Re: Expert opinion on the potential impact on traffic safety at the Railway Crossing (LXM ID 349) located on Railway Street in Corrimal, NSW

Railway Crossing (LXM ID 349) located on Railway Street in Corrimal, NSW

Stage 5 (Existing road) Road Safety Audit

Table 4.4: Road safety audit findings

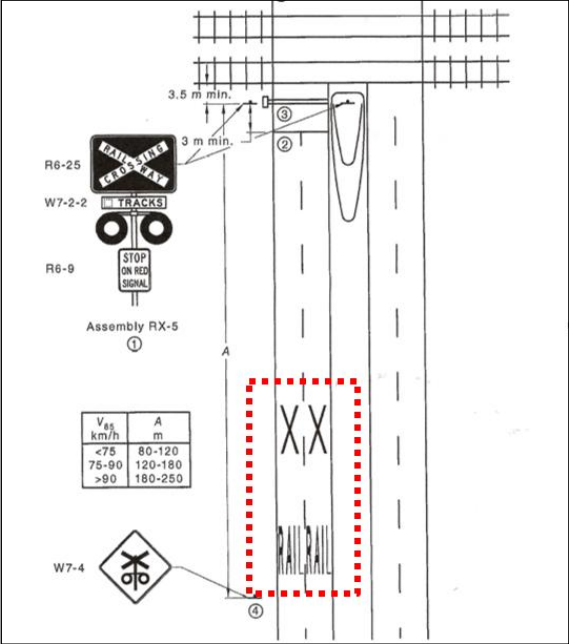
No.	Approximate location	Description of findings	Risk rating (likelihood / consequence)
1	Railway Street, on the eastern approach to the Railway Crossing	Railway Crossing Pavement Markings 'RAIL X' is missing on Railway Street, on the eastern approach to the Railway Crossing (refer to Photo 4.1, and Figure 4.1). The 'RAIL X' markings are a critical visual cue for drivers regarding the presence and location of the railway crossing. The lack of these markings could increase the chance of a driver being less alert to the presence of the Railway Crossing, thus increasing the chance for an accident to occur. The absence of these markings may reduce driver alertness, potentially increasing the risk of a collision, particularly under low visibility or high-speed conditions. However, due to the presence of other visual and environmental cues, it is considered highly unlikely that a driver would entirely overlook the existence of the Railway Crossing, despite the missing 'RAIL X' markings.  Photo 4.1: 'RAIL X' markings are missing on Railway Street, on the eastern approach to the Railway Crossing (Photo: Traffic Engineering Centre Pty Ltd)	Medium (Negligible / Extreme)

No.	Approximate location	Description of findings	Risk rating (likelihood / consequence)
1 Cont'd		 Figure 4.1 (Source: AS1742.7:2016) Recommended mitigation measure: The 'RAIL X' markings are to be painted on Railway Street, on the eastern approach to the Railway Crossing, in accordance with the AS1742.7:2016. This measure would eliminate the chance of an incident being caused by the lack of 'RAIL X' pavement marking.

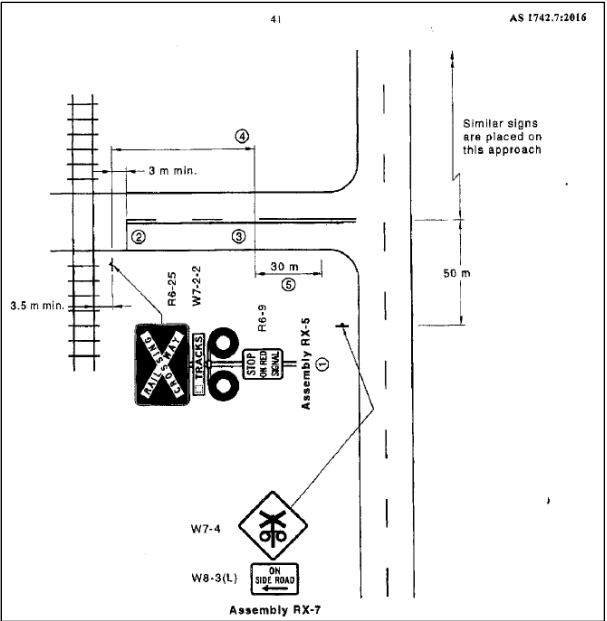
No.	Approximate location	Description of findings	Risk rating (likelihood / consequence)
2	Raised medians on Railway Street, on both sides of the Railway Crossing	'KEEP LEFT' (R2-3) signs are missing from the noses of the raised median islands (refer to Photos 4.2 to 4.6), despite the fact that traffic can physically pass on either side. However, it is essential that all approaching traffic passes to the left of these islands in accordance with standard road rules and design intent. In the absence of these regulatory signs—and without the kerb faces painted white, drivers may overlook the presence of the islands, even during daylight hours, and particularly under adverse lighting conditions (refer to Photos 4.5 & 4.6). This increases the risk of a vehicle striking the island, potentially resulting in vehicle damage and injury to occupants.  Photo 4.2: 'KEEP LEFT' sign is missing on the raised median on approach to the Railway Crossing (Photo: Traffic Engineering Centre Pty Ltd)	Negligible (Medium / Negligible)

No.	Approximate location	Description of findings	Risk rating (likelihood / consequence)
2 Cont'd		 Photo 4.3: 'KEEP LEFT' sign is missing on the raised median on the approach to the Railway Crossing (Photo: Traffic Engineering Centre Pty Ltd)  Photo 4.4: 'KEEP LEFT' sign is missing on the raised median on the approach to the Railway Crossing (Photo: Traffic Engineering Centre Pty Ltd)

No.	Approximate location	Description of findings	Risk rating (likelihood / consequence)
2 Cont'd		 Photo 4.5: 'KEEP LEFT' sign is missing on the raised median on the approach to the Railway Crossing (Photo: Traffic Engineering Centre Pty Ltd)  Photo 4.6: 'KEEP LEFT' sign is missing on the raised median on the approach to the Railway Crossing (Photo: Traffic Engineering Centre Pty Ltd) Recommended mitigation measure: 'KEEP LEFT' (R2-3) signs to be installed on the raised medians' noses to minimise the risk of a vehicle striking the medians.
